# UNITED STATES PATENT AND TRADEMARK OFFICE

APPLICATION NO.	FILING DATE	FIRST NAMED INVENTOR	ATTORNEY DOCKET NO.	CONFIRMATION NO.
10/581,351	06/01/2006	Tobias Horté	09546-029US1	4980
26211 7590 06/11/2009 FISH & RICHARDSON P.C. P.O. BOX 1022 MINNEAPOLIS, MN 55440-1022				
EXAMINER				
DUONG, THO V				
ART UNIT		PAPER NUMBER		
3744				
NOTIFICATION DATE		DELIVERY MODE		
06/11/2009		ELECTRONIC

### Office Action Summary

**DETAILED ACTION**

Figure A: the modified figure corresponds to figure 3 with limitation of second plate shown.

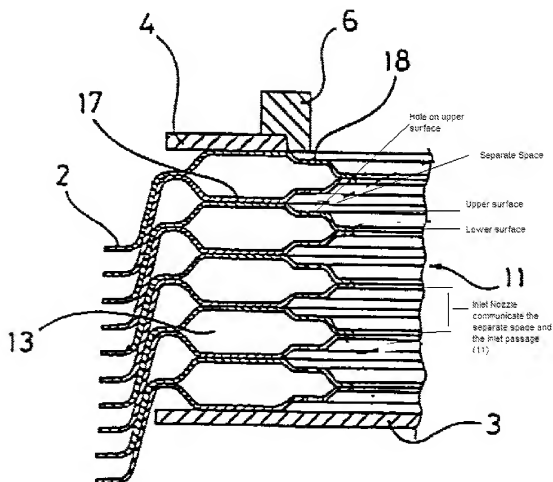
Claims 25-26,32,33,39,40,41,44,45,46,47 and 48 are rejected under 35 U.S.C. 102(b) as being anticipated by Anderson et al. (US 5,924,484). Anderson discloses (figures 1 and 3) a plate heat exchanger comprising a plate package, the plate package including a number of first heat exchanger plates and a number of second heat exchanger plates; the plates (2) being permanent joined to each other and arranged beside each other so that a first plate interspace (13) is formed between each pair of adjacent first and second heat exchanger plate, and so that a second plate interspace (shown as outside of 13) is formed between each pair of adjacent second heat exchanger plates and first exchanger plates, wherein the first plate interspaces (13) and the second interspaces are separated from each other and provided beside each other in alternating order in the plate package; wherein substantially each heat exchanger plate has at least a first porthole and a second port (9), the first port holes forming a first inlet channel (11) to the first plate interspaces and the second portholes forming a first outlet channel from the first plate interspaces; wherein the plate package includes a separate space (15) for each of the first plate interspaces, which space is closed to the second plate interspaces; wherein the separate space (15) communicates with the first inlet channel via an inlet nozzle (shown in figure A as gap between portion 16), which forms a throttling with significantly reduced flow area (compare with port (9)), and with the respective first plate interspace via an outlet nozzle (18), which forms a throttling with significantly reduced flow area; the separate space (15) is provided in the proximity of the inlet channel. Regarding claims 28 and 30,32-34, each of the second heat

exchanger plates (2); each of the heat exchanger plates (2) includes a central extension plane, an upper plate plane on one side of the central extension and a lower plate plane on the other side of the central extension plane; each of the second heat exchanger plates includes an upper surface area, which extends around the first porthole and which delimits the separate space, and the upper surface area is located at the level of the upper plate plane; the upper surface area of the second heat exchanger plates is located partly opposite to the lower surface area of the first plates for forming the separate space between these surface areas, the outlet nozzle is formed by a respective hole, which extends through the upper surface area; the heat exchanger includes an end plate, which is provided adjacent to one of the second heat exchanger plates and closes the hole of the outlet nozzle of the second heat exchanger plate (figure 3). Regarding claim 36, Anderson discloses (figure A) each of the second heat exchanger plate includes a lower surface area, which extends around the first port hole (9) between the first port hole and the upper surface area, wherein the lower surface area is located at the level of the lower plate plane; Anderson further disclose (figure A) that each of the first heat exchanger plate includes a lower surface area, which extends around the first porthole (9) and which delimit the separate space, wherein the upper surface area of the second heat exchanger plate is located partly opposite to the lower surface area of the first heat exchanger plates for forming the separated space (15) between these surface areas; the lower surface area of the second heat exchanger is located partly opposite to the upper surface of the first heat exchanger plate, wherein these two surface areas partly abut each other in the plate package. Regarding claims 29,31, 39,40 and 41, another interpretation of the separate space is shown in figure B.

the inlet nozzle is located opposite to the lower surface area of the first heat exchanger plates (inlet nozzle located above the lower surface area); the outlet nozzle (18), with regard to the central extension plane, is displaced in relation to the lower surface area of the first heat exchanger plates (the outlet nozzle (18) is not located on the lower surface area of the first heat exchanger plate); the first plate and second plate interspaces form first and second fluid passages for two different fluids; each of the heat exchanger plate further has a third and forth port holes (figure 1).
